CITY OF West Linn

STAFF REPORT FOR THE HISTORIC REVIEW BOARD

FILE NUMBER: DR-23-01

REQUEST: Provide a recommendation to the Planning Commission regarding a Class II Design Review at 1919 & 1949 Willamette Falls Drive

2 SECOND FLOOR PLAN + EAST & 12th STREET ELEVATIONS

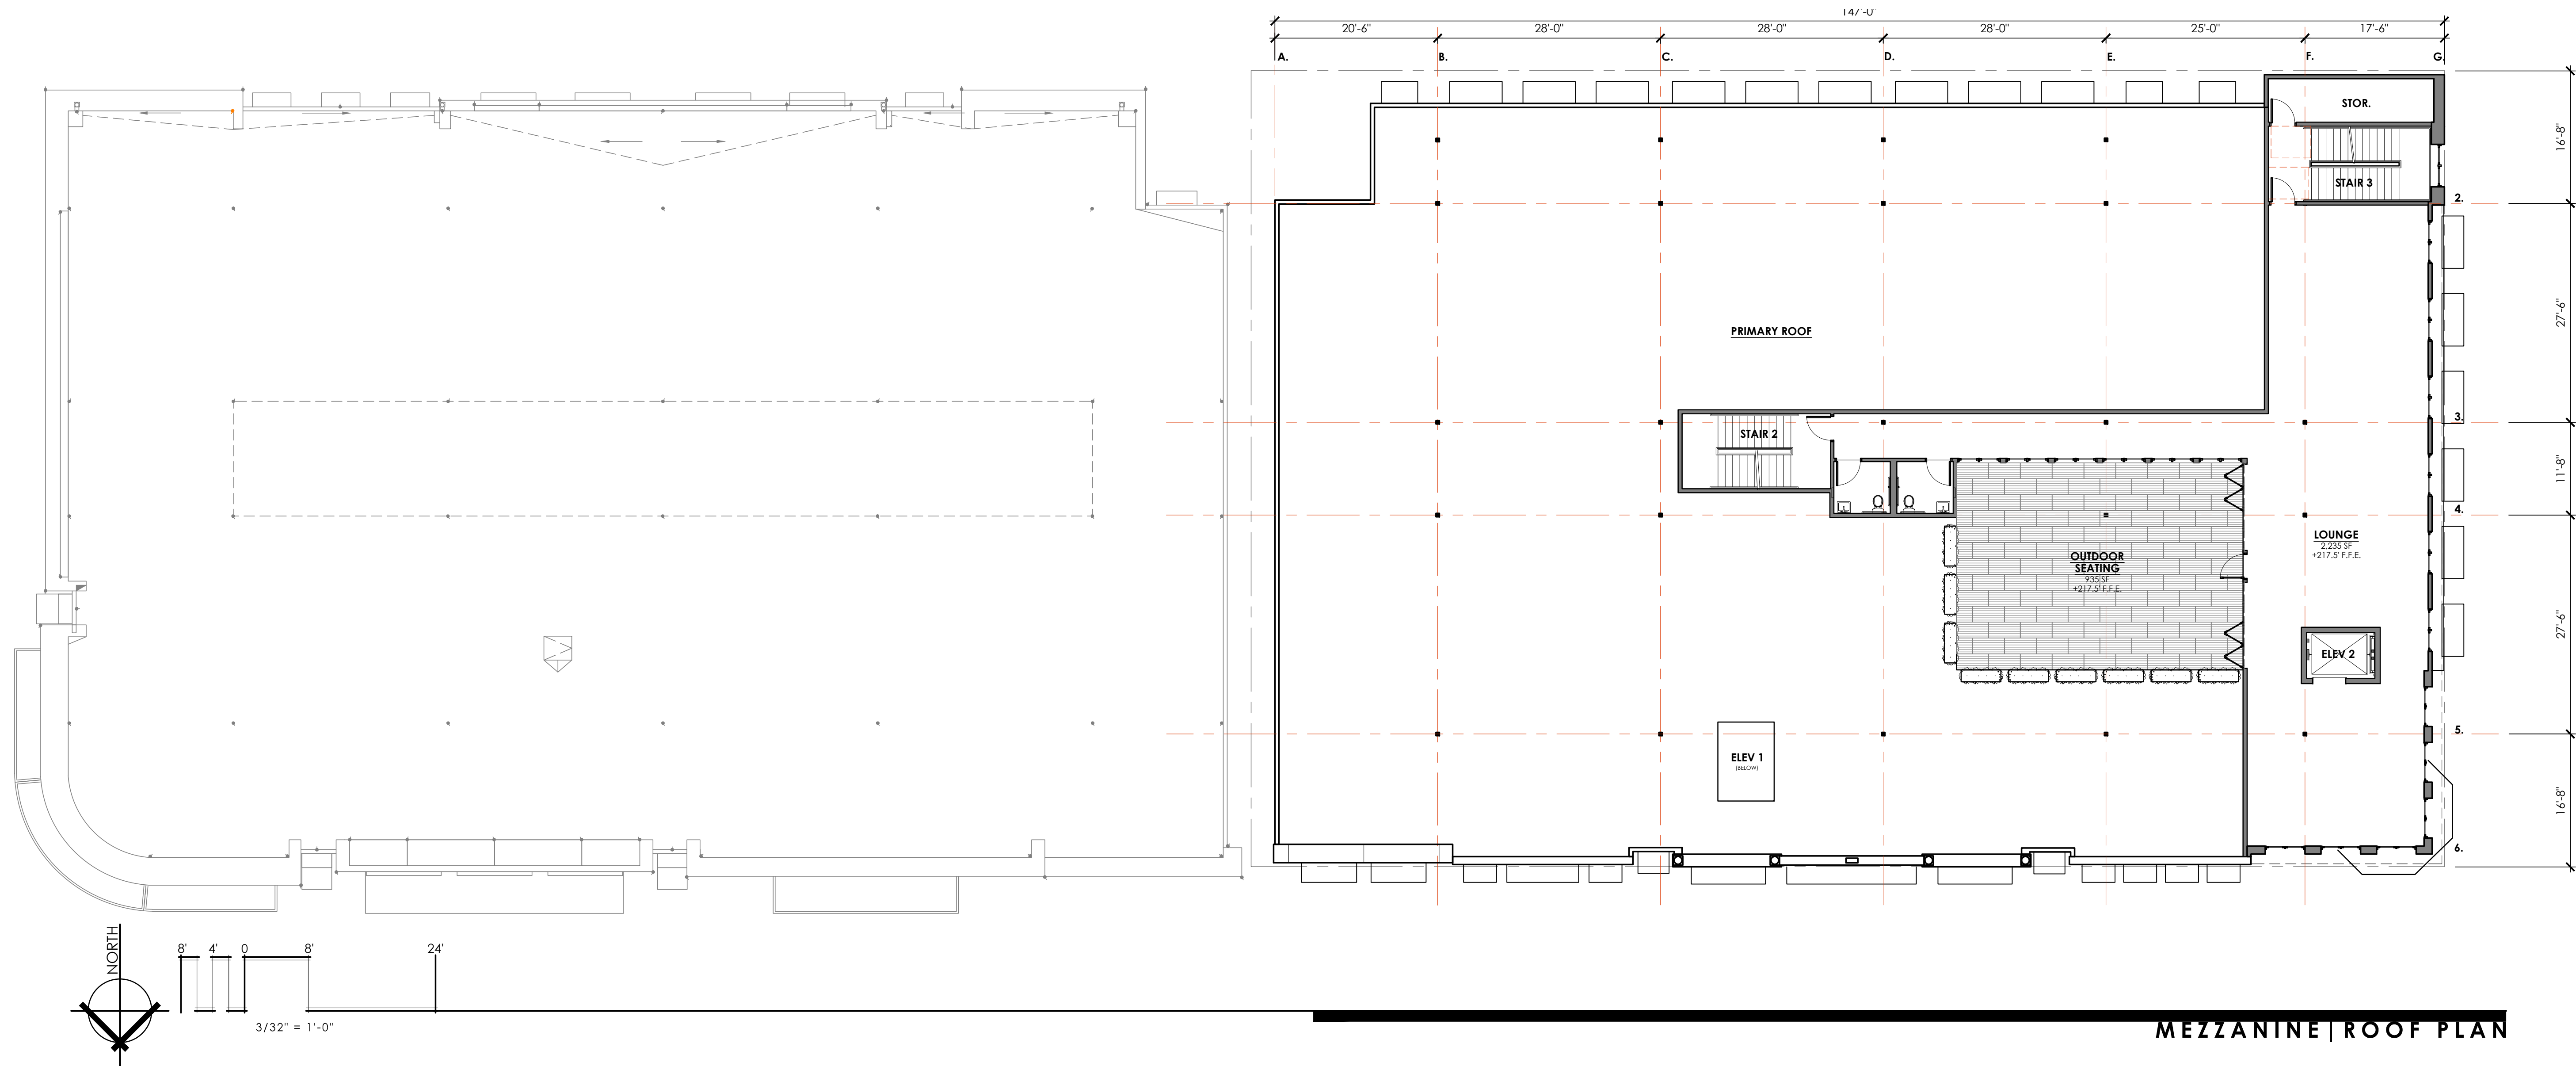
3. **Vertical Breaks.** Prior to issuance of building permits, the applicant shall submit building permit plans with revised western and southern elevations that demonstrate compliance with CDC 58.080.C.7 that requires strong vertical breaks or lines regularly spaced every 25 to 50 feet.

The longest façade plane along Willamette Falls Drive without a vertical break is approximately 45 feet per the conceptual elevations in HRB-01. As the primary façade, this is where the variation is most important for maintaining streetscape continuity. Side and rear elevations exceed this standard at 58 feet on the western façade facing 12th street, and 83 feet facing Knapps Alley. To ensure compliance with this standard, a condition of approval has been added requiring the submission of revised plans at the building permit stage that demonstrate compliance with this standard. As conditioned, this standard will be met.
